Coastal Access Modification Report GAL-MR1

Proposed changes to the submitted England Coast Path proposals
for Gretna to Allonby

Location affected: **Burgh Marsh/Burgh-by-Sands, Cumbria**

9th May 2022

Map GAL-MR1g - Burgh Marsh/Burgh-by-Sands - Restrictions and Exclusions

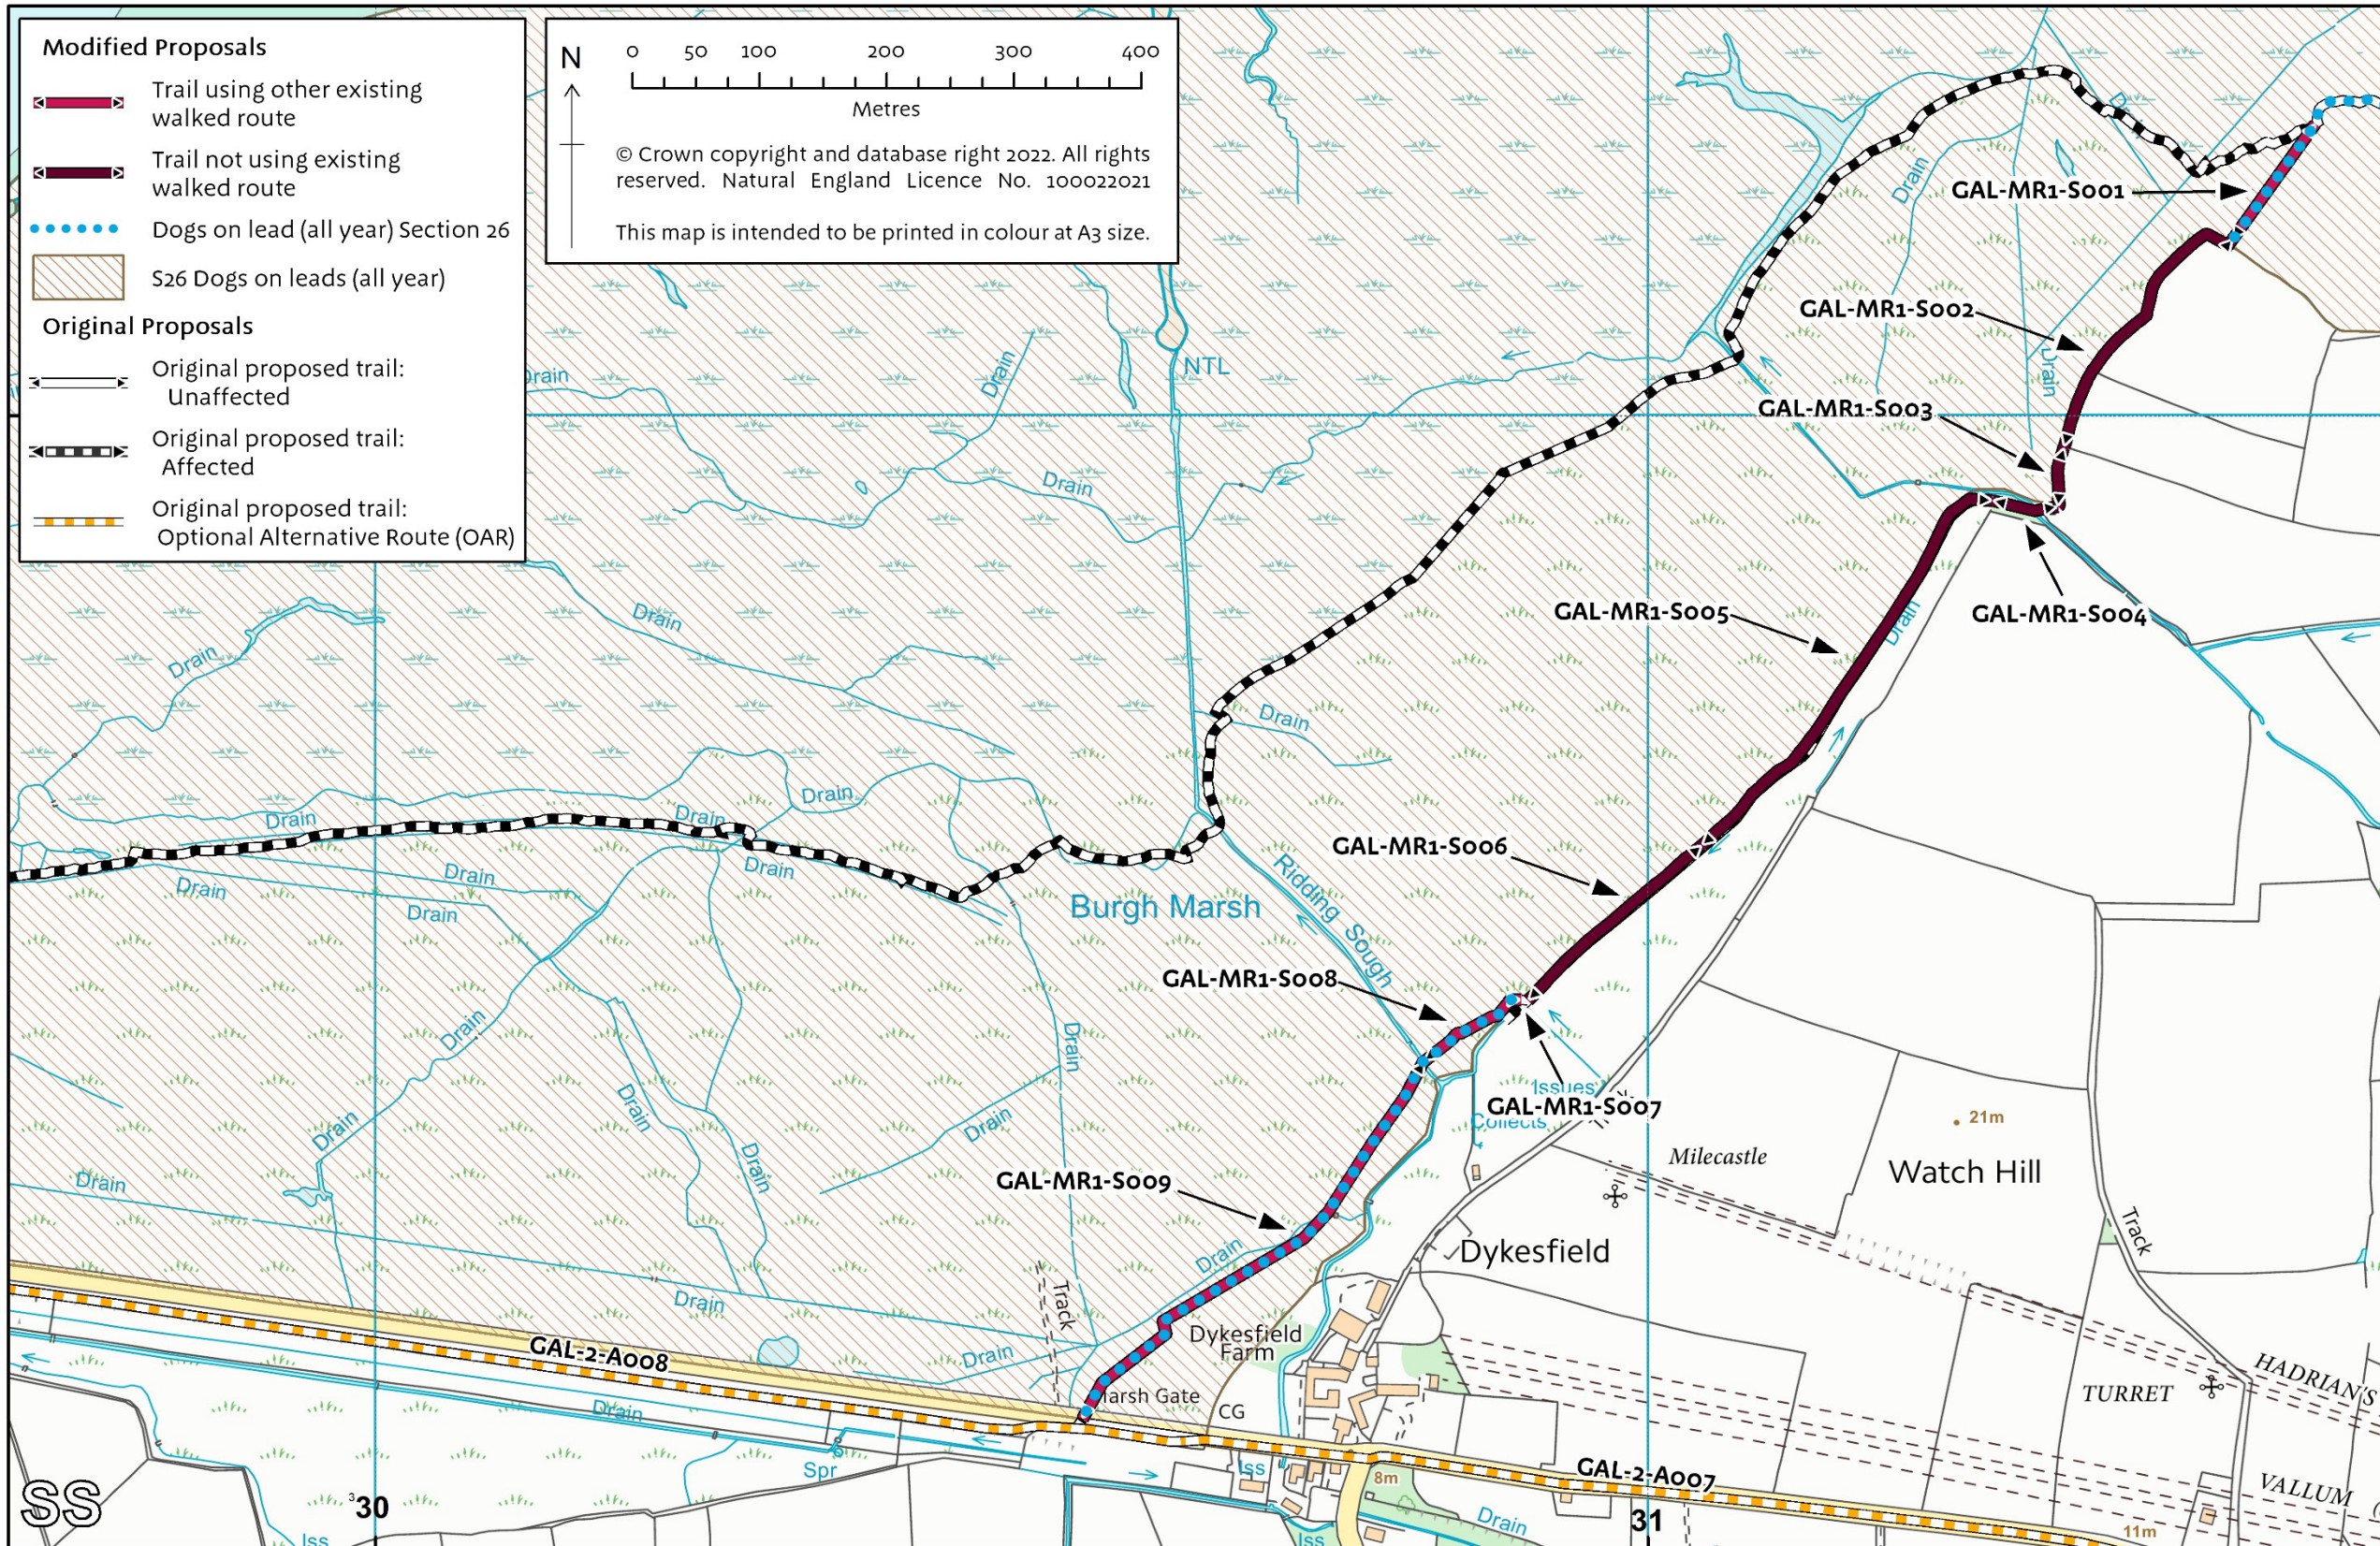
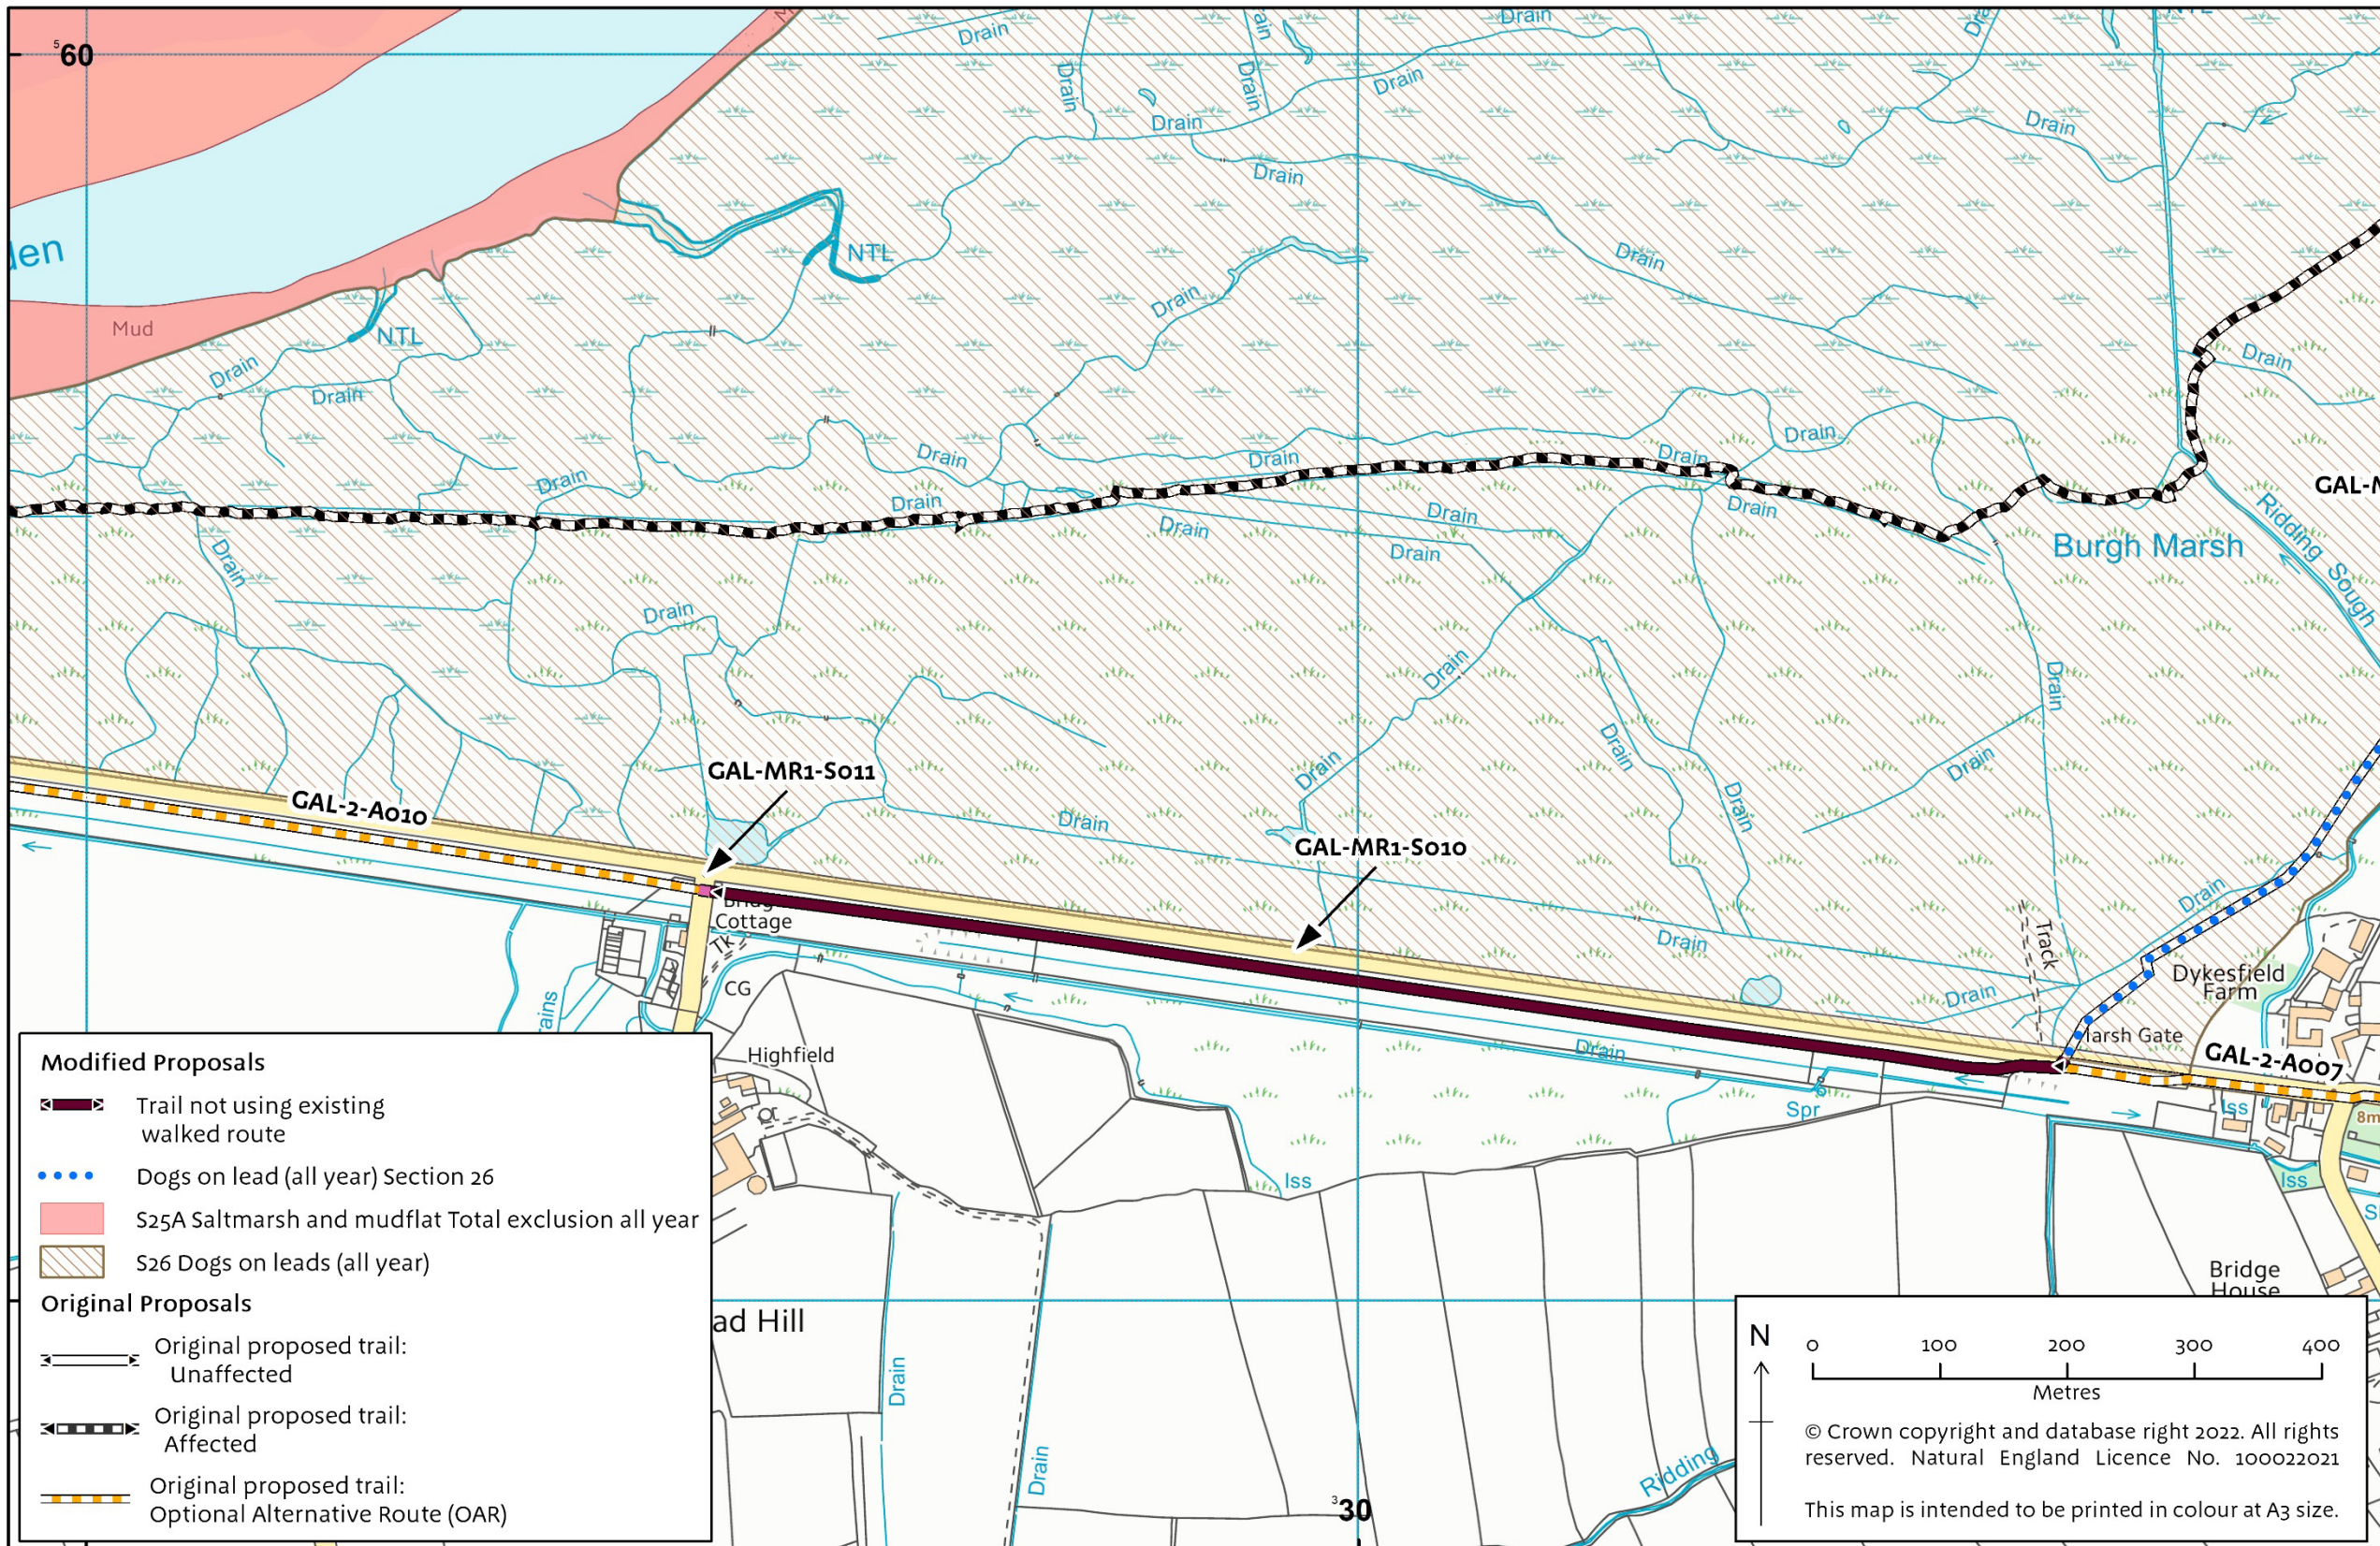
Where the proposed new route is aligned on the open marsh, it would continue to be subject to the existing proposed restriction with the effect that all dogs should be kept on leads at all times of the year.

Refer to 'Restrictions and Exclusions' maps below – GAL-MR1g/1h/1i.
